Appeal PD-A21-0001

TRAFFIC STUDY REVIEW

Of The Kimley Horn Transportation Impact Study For The Grocery Outlet in Cameron Park, CA

PRISM Engineering Review of Kimley Horn Traffic Impact Analysis Report

Figure 1. PM Queue exceeds pocket length, blocks THRU lane.

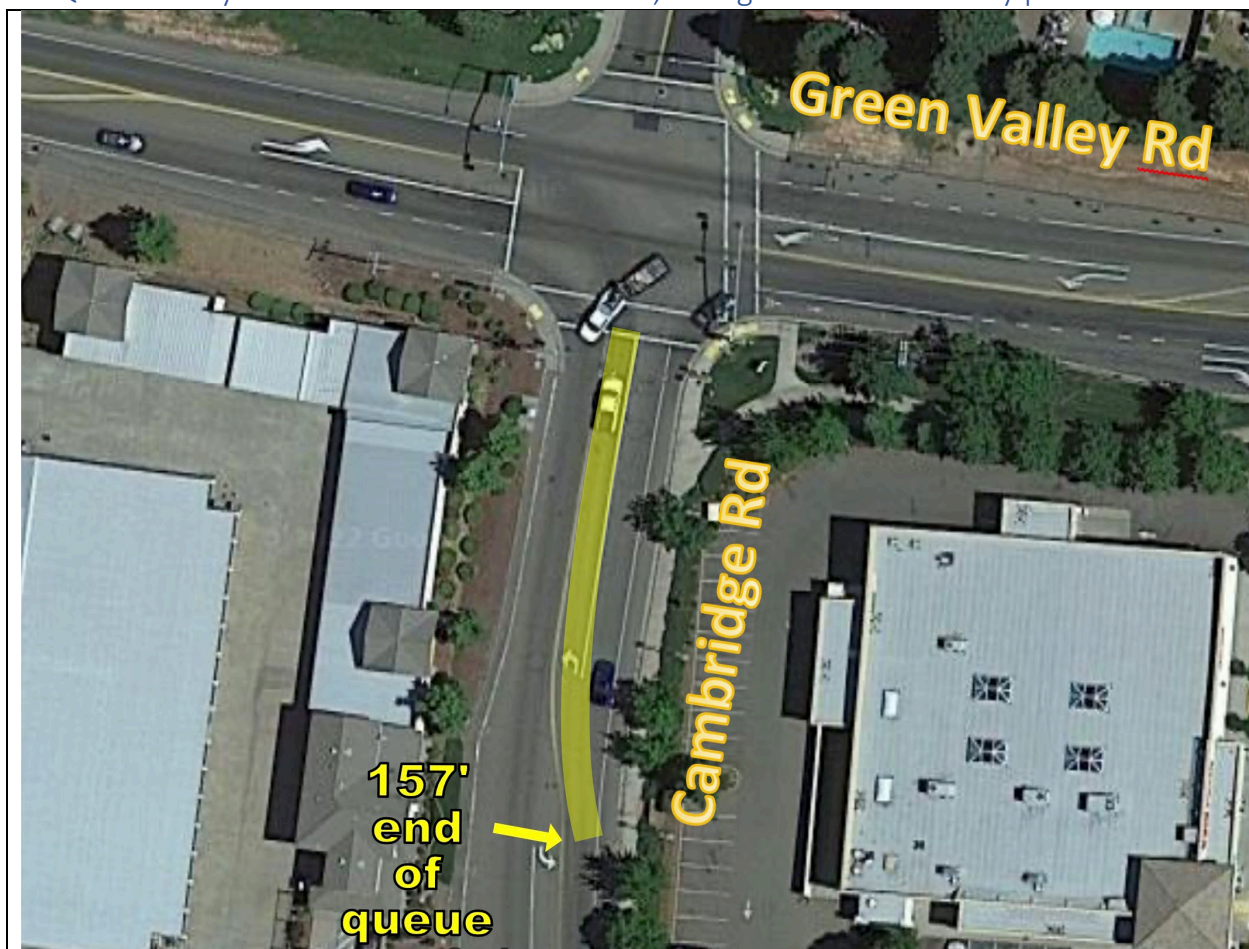
At this intersection #2, Cambridge Road and Green Valley Road, the NBL pocket overflowed in the analysis as shown in Table 8 of the report, and no mitigation was suggested, but the existing condition deficiency was approved. Table 8 said there is 125' of striped storage, but actually

Figure 2. PM Queue exceeds pocket length, blocks THRU lane.

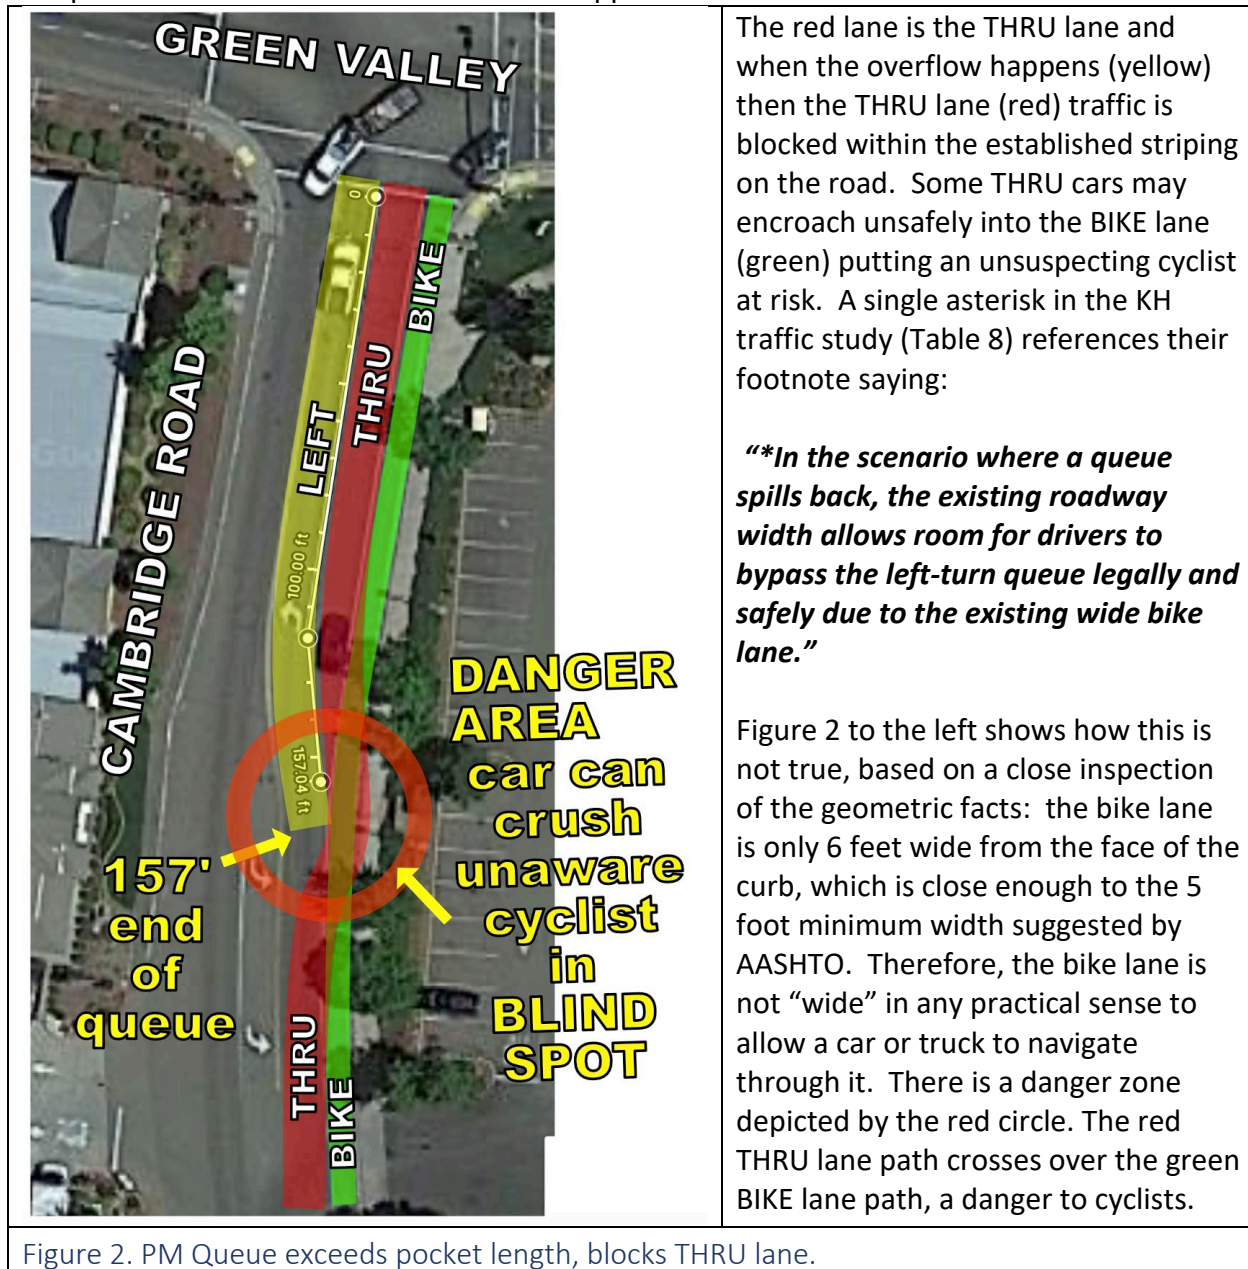
there is only 118'. The 95th percentile queue is 157' which means that 95% of the time the queue will be shorter than 157'. Since the pocket is only 118' long it will be overflowed many times during the peak hour. Figure 2 shows this graphically where the yellow lane is the LEFT turn pocket and with an overflow that will happen 5% of the time.

In order to have an abundance of caution towards cyclists using this bike lane, it is an unsafe idea to suggest that vehicles can suddenly occupy this lane to go around a queue, without warning to a cyclist who may be using the lane. This is not a solution to ignore this safety deficiency in the Cambridge Road cross section south of Green Valley Road. There are MUTCD regulatory signs that would have to let cyclists know there are in potential danger and have to share the road, the Class 3 bike lane or even a warning sign with “share the road” text could be

installed. If such signs are installed, then the bike lane would need to be removed to prevent confusion. Why have a bike lane if cars and bikes are to “share the road?” It would be safer and more clear if the cyclist KNEW that they might have to share the road with a car, than to think that they have the right of way in while riding in a striped bike lane which communicates right-of-way, only to be surprised by a vehicle turning or swerving into it. There needs to be an abundance of caution towards cyclists in roadway design that includes bike lanes, or it creates a liability on the County.

The 157' long queue in the left turn pocket as shown in Figure 2, will happen about 5% of the time during the peak hour, but it is important to note that the left turn pocket is actually only 118' long, and not 125' as stated in the KH report. Any queue past that 118' distance means the lane will be overflowed into the through lane causing a safety problem. Note in Table 8 that the column heading is the 95th % Queue, and it reports an overflow queue of 157' that will happen about 5 % of the time, or about 2 or 3 times during the peak hour. I disagree that the use of a bike lane on a curve for drivers to pass by this minimum of 157' long queue, three times an hour, is a legal and safe maneuver for the potential cyclists who have no choice in the matter, the impulsive unexpected driver maneuver into the bike lane. The last thing that a cyclist wants to experience is being caught in a blind spot of a driver's vehicle who decides to fully encroach the bike lane that they currently occupy, and finding themselves being crushed towards the sidewalk curb and crash. Figure 3 shows a drivers view of this section of Cambridge Road, and how dangerous this THRU lane (red) maneuver could be.

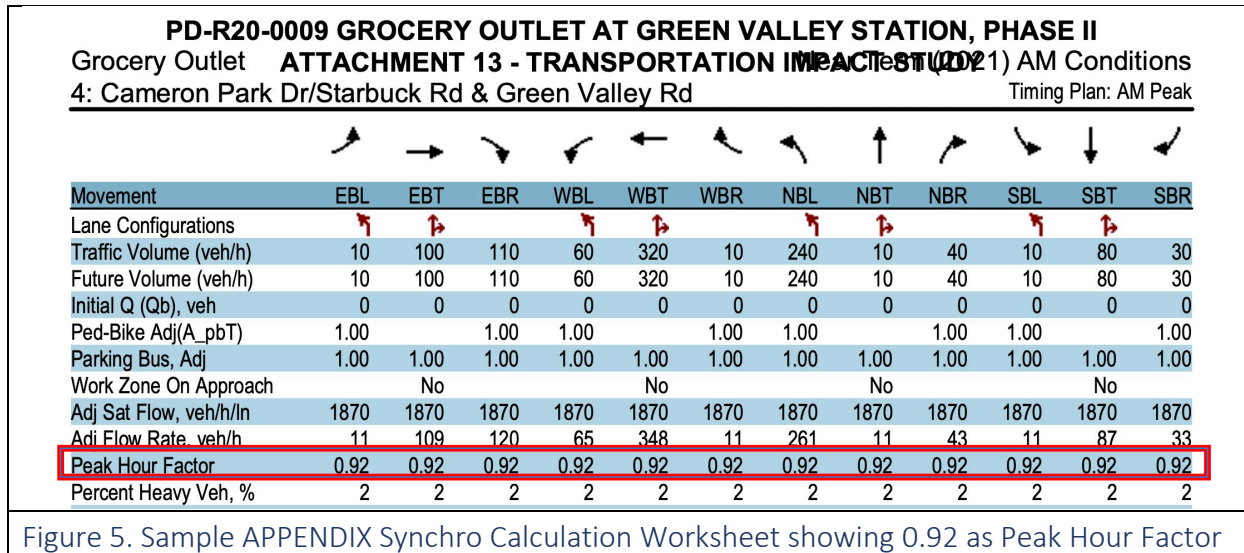
In the appendix output shown below, it can be seen that the Peak Hour Factor parameter used in all calculations was a generic 0.92 across the board for all 12 turning movements at each intersection analyzed in the KH study. This leads to errors and incorrect calculations of level of service, usually under-estimating the impacts of traffic, and therefore safety if the traffic conditions are creating high delays. Figure 5 shows the relevant appendix calculation sheet output as a sample.

The KH traffic study used the same Peak Hour Factor (PHF) of 0.92 for all approaches and for all turning movements. This is a mistake, as each intersection has a traffic count and from the traffic count all of the individual PHF values are determined. The KH study went with software defaults and the results of the LOS and delay are most likely incorrect, and probably missing a full impact of the turning movement data.
